## **ADDENDUM NO. 2**

DATE: January 2, 2020

PROJECT: Owosso Water Treatment Plant Wash Water Pump and Piping Replacement  
DWRP #7457-01

OWNER: City of Owosso

P-201 WASH WATER PUMP & PIPING PLAN & SECTIONS  
P-203 HIGH SERVICE PIPE PLAN

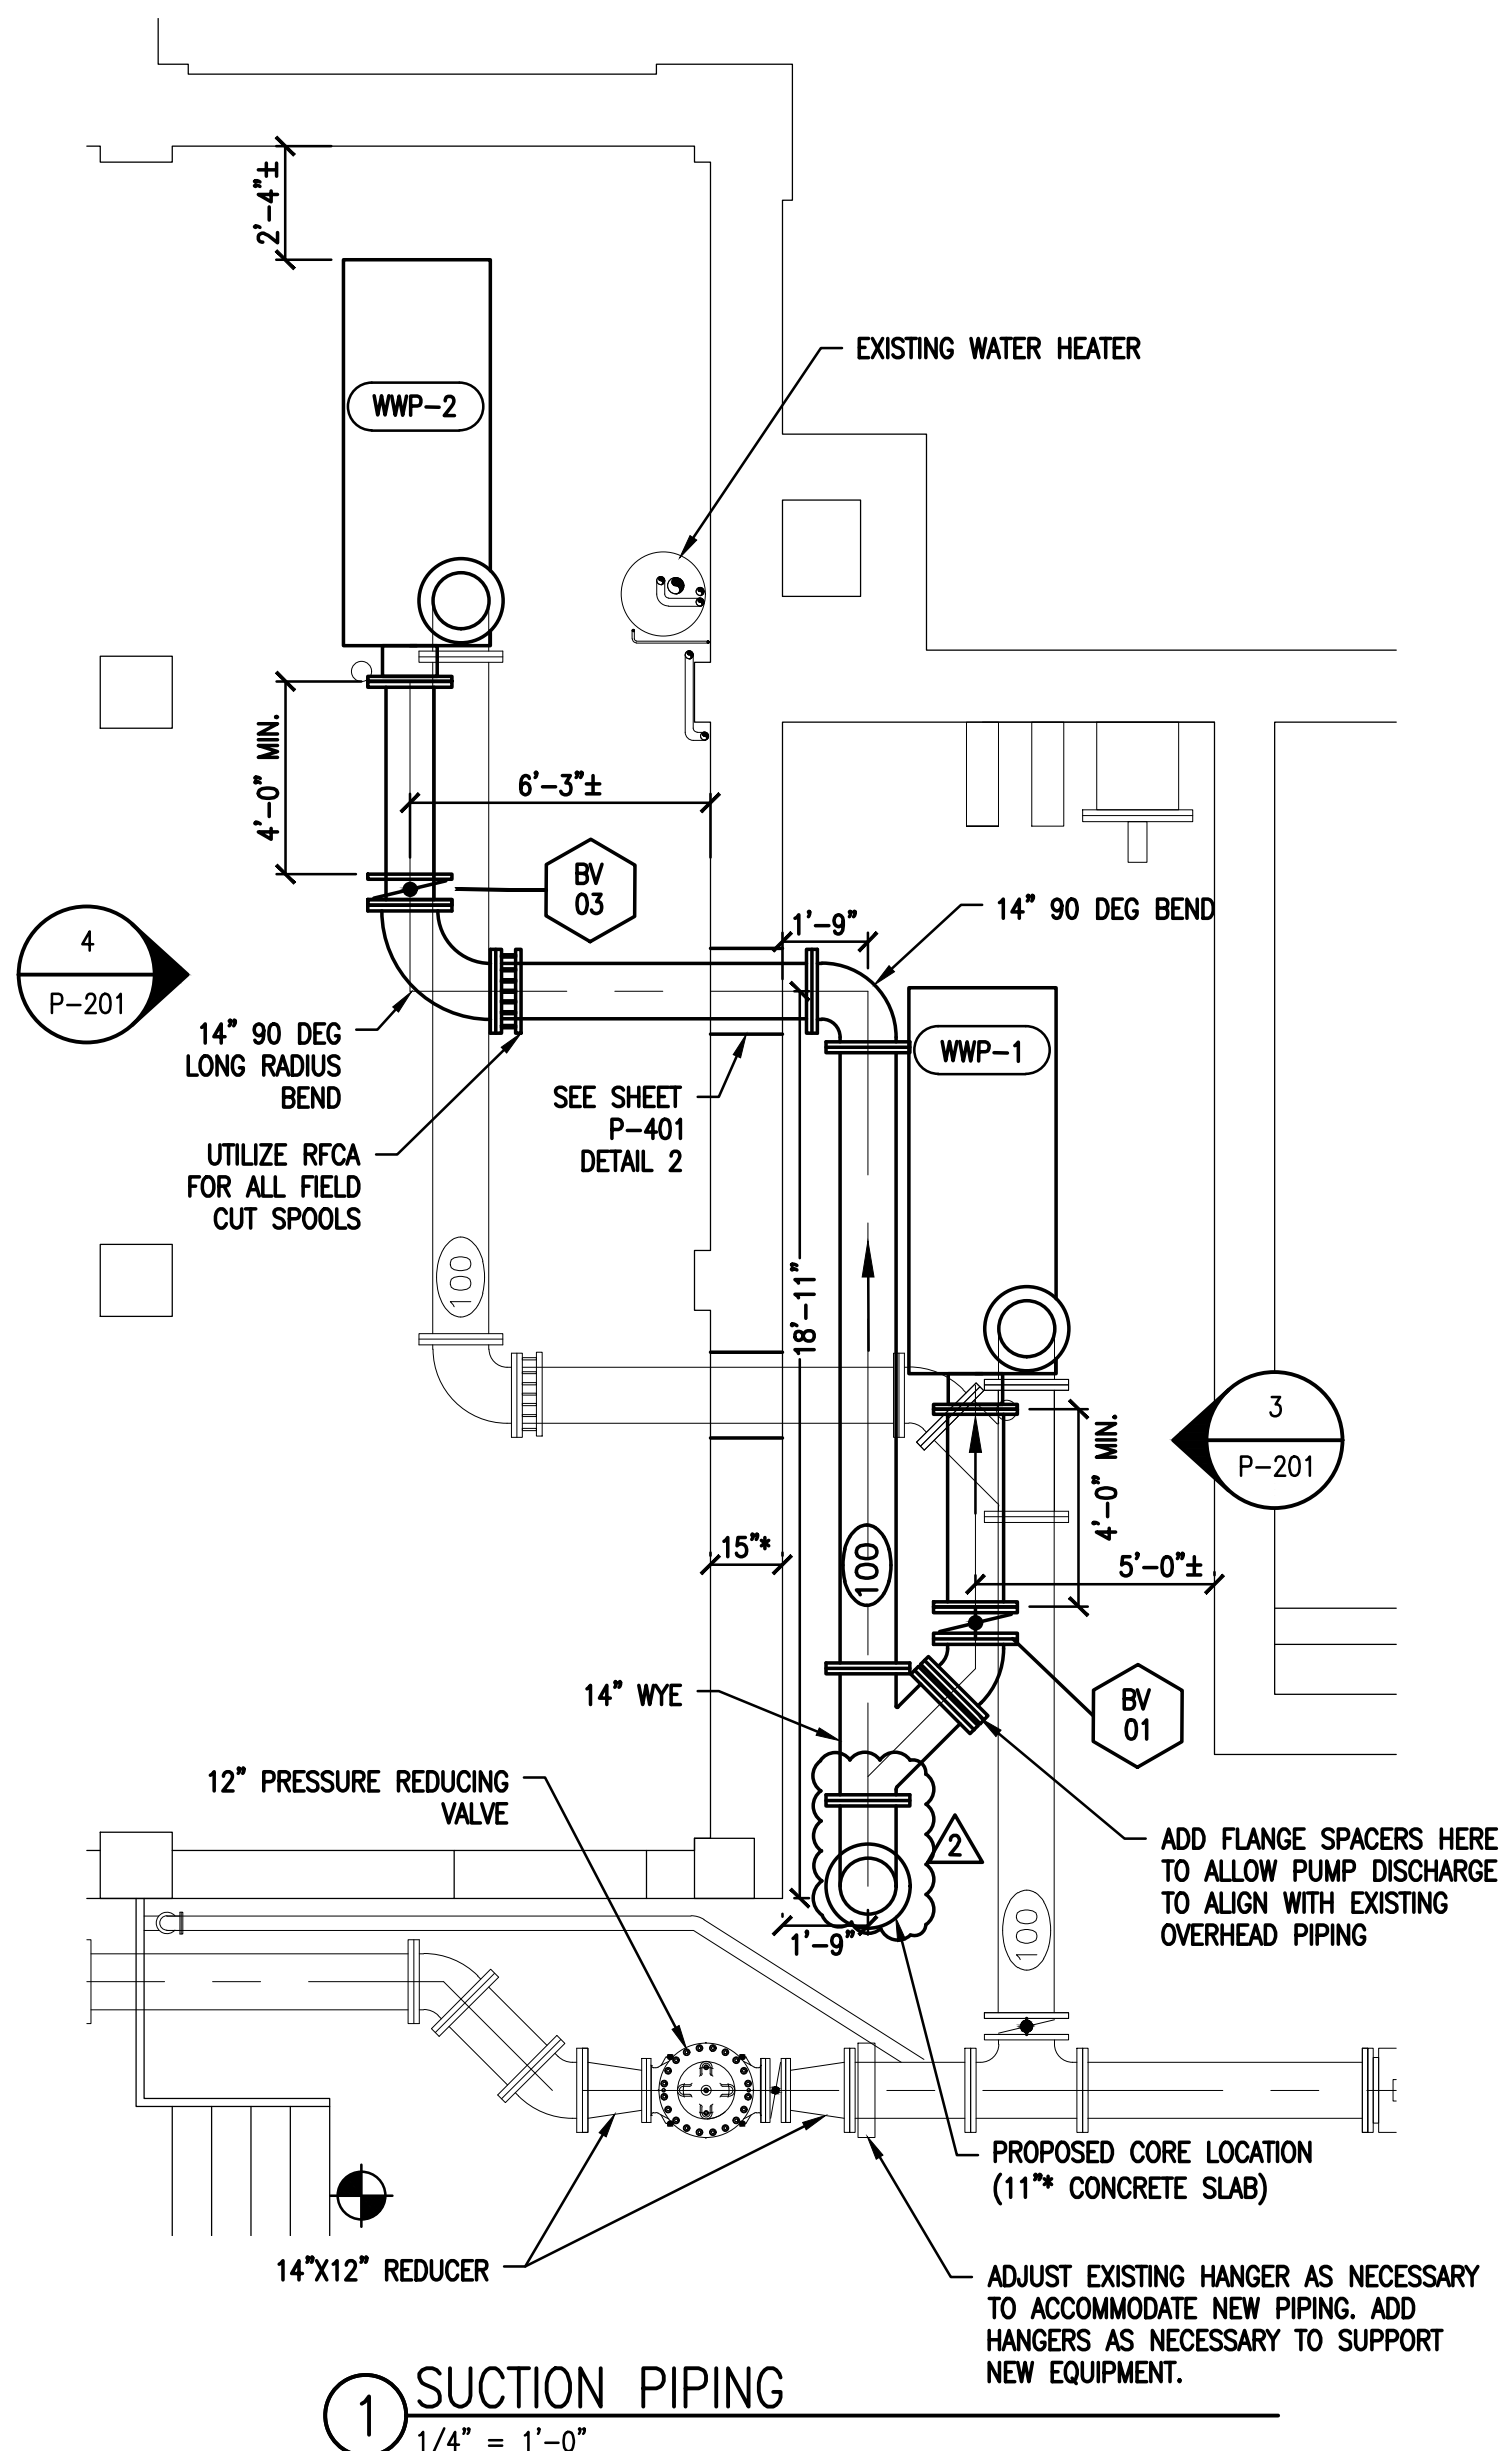
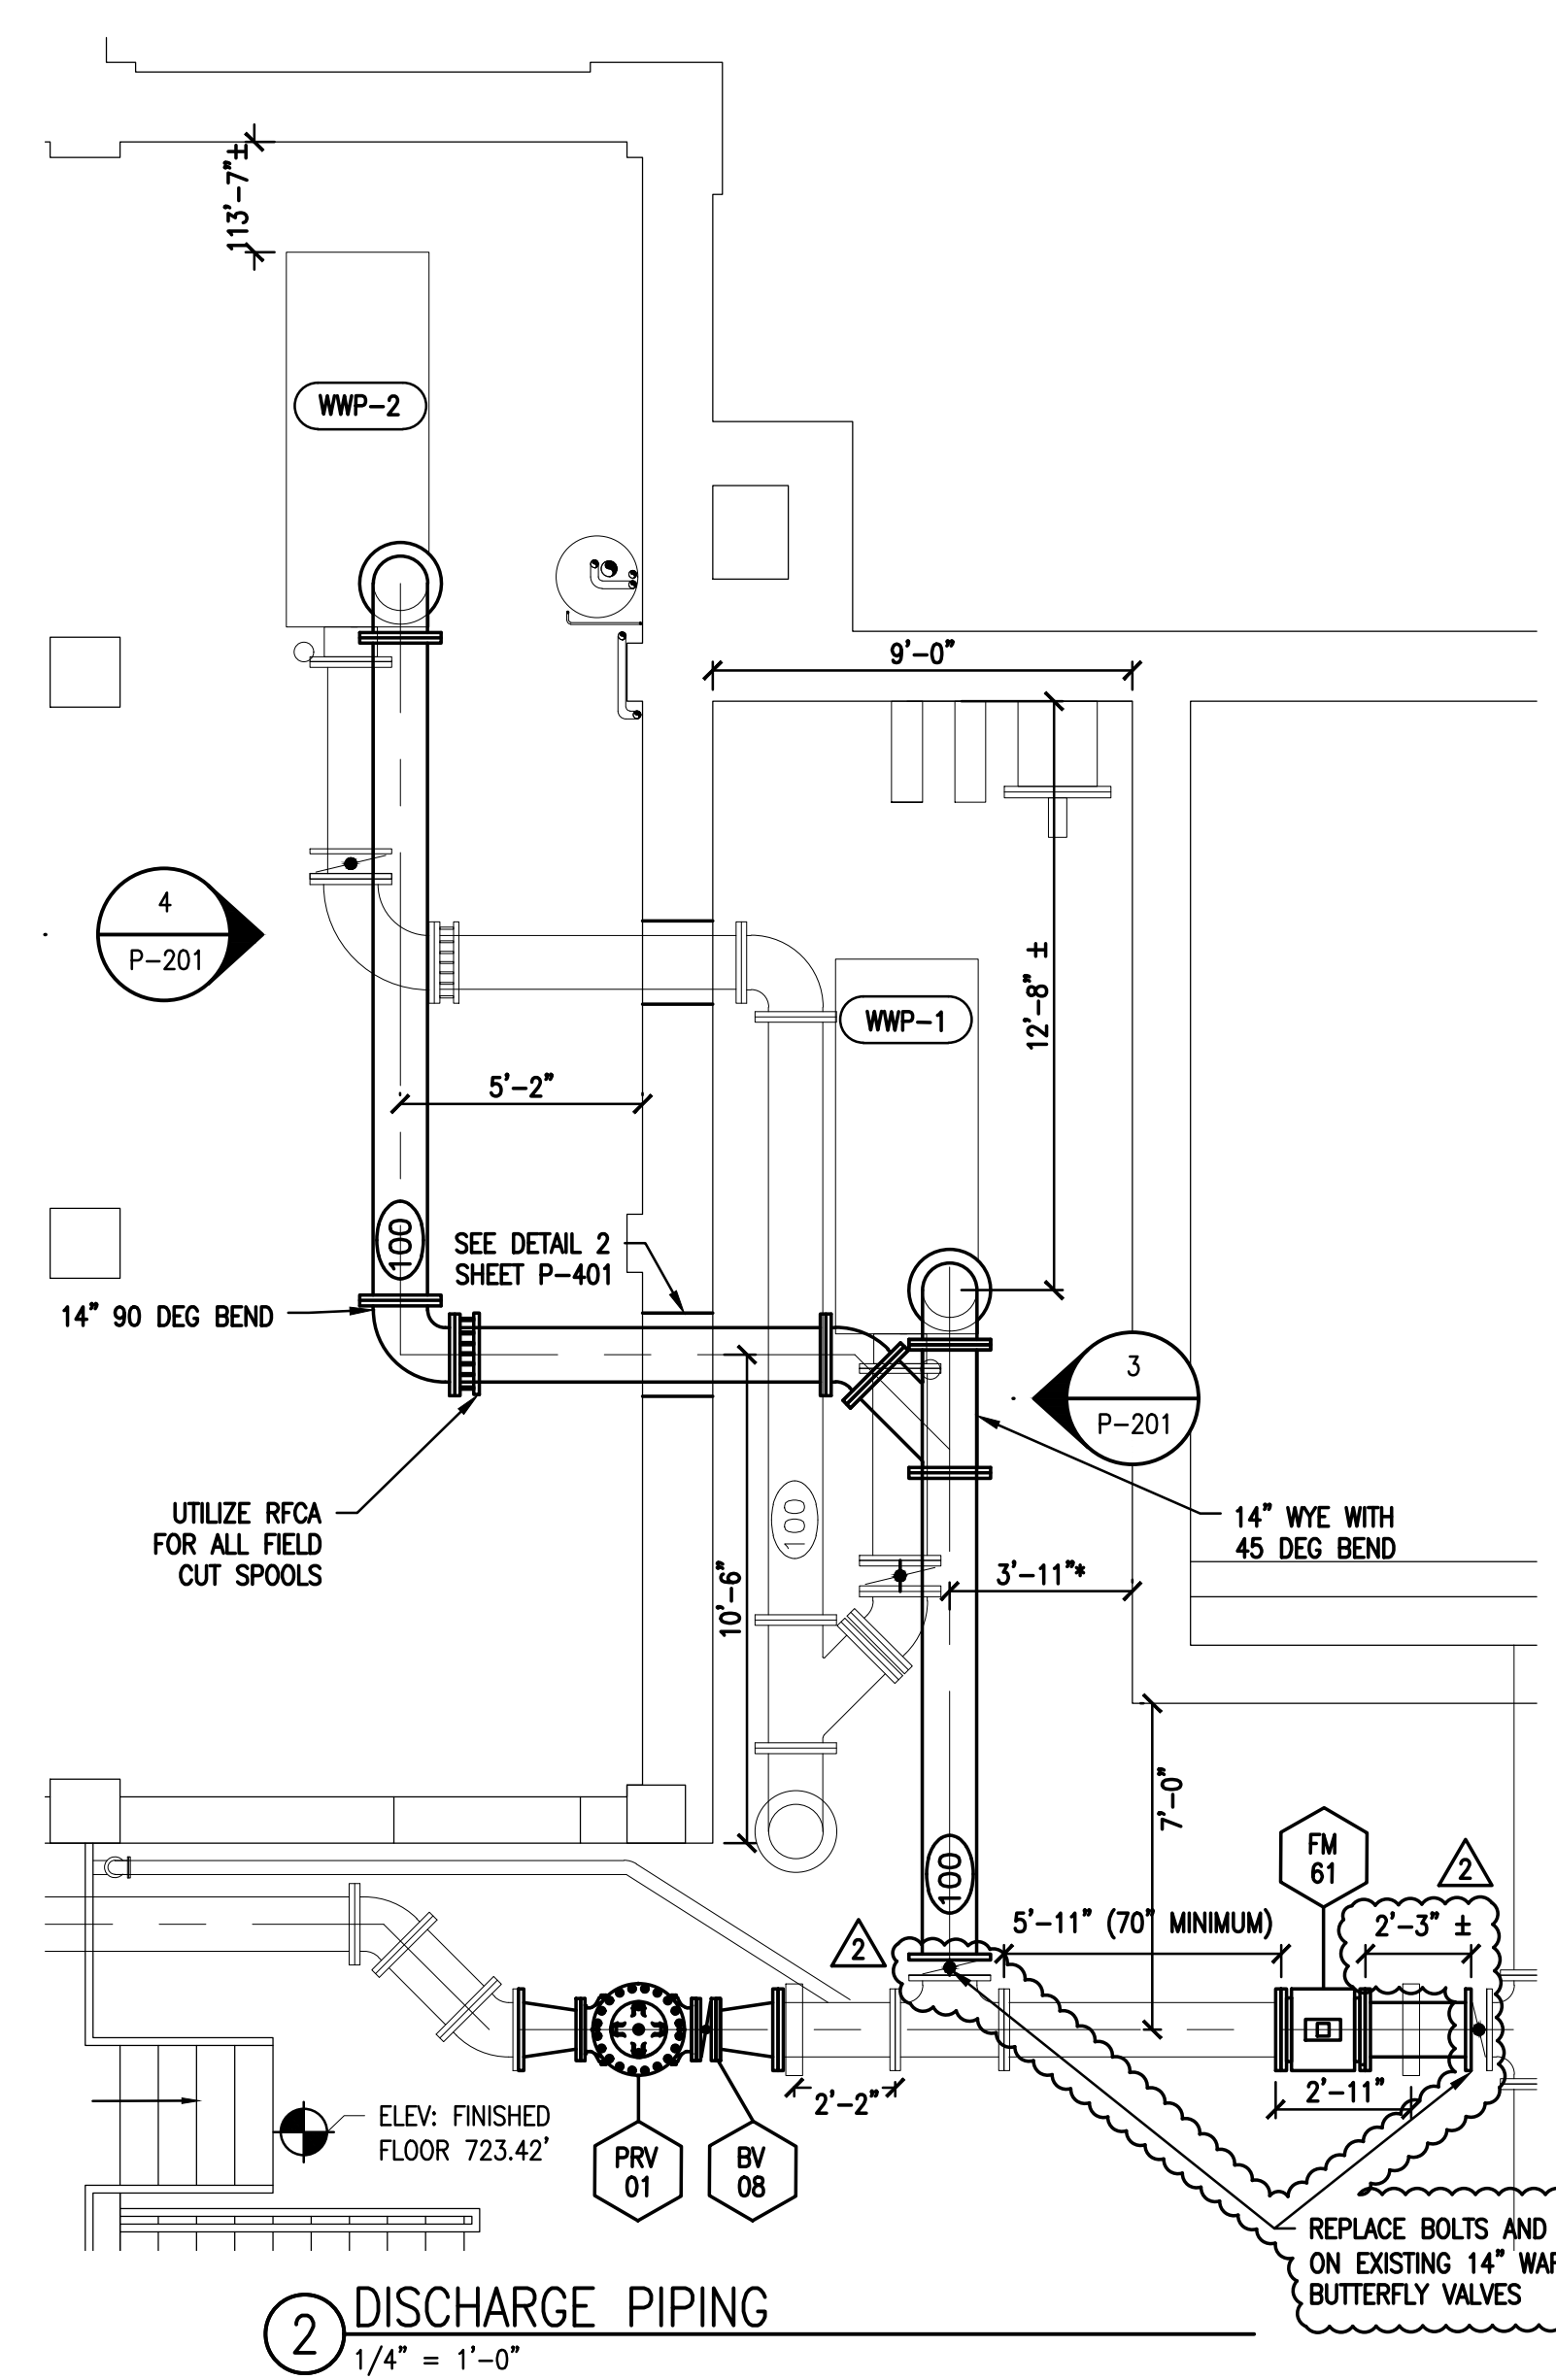
- 3. SHEET P-201 WASH WATER PUMP & PIPING PLAN & SECTIONS. Remove and replace this sheet.
- 4. SHEET P-203 HIGH SERVICE PIPE PLAN. Remove and replace this sheet.
- 5. SHEET P-301 PUMP, VALVE & PIPE SCHEDULES – change the following valve accessory
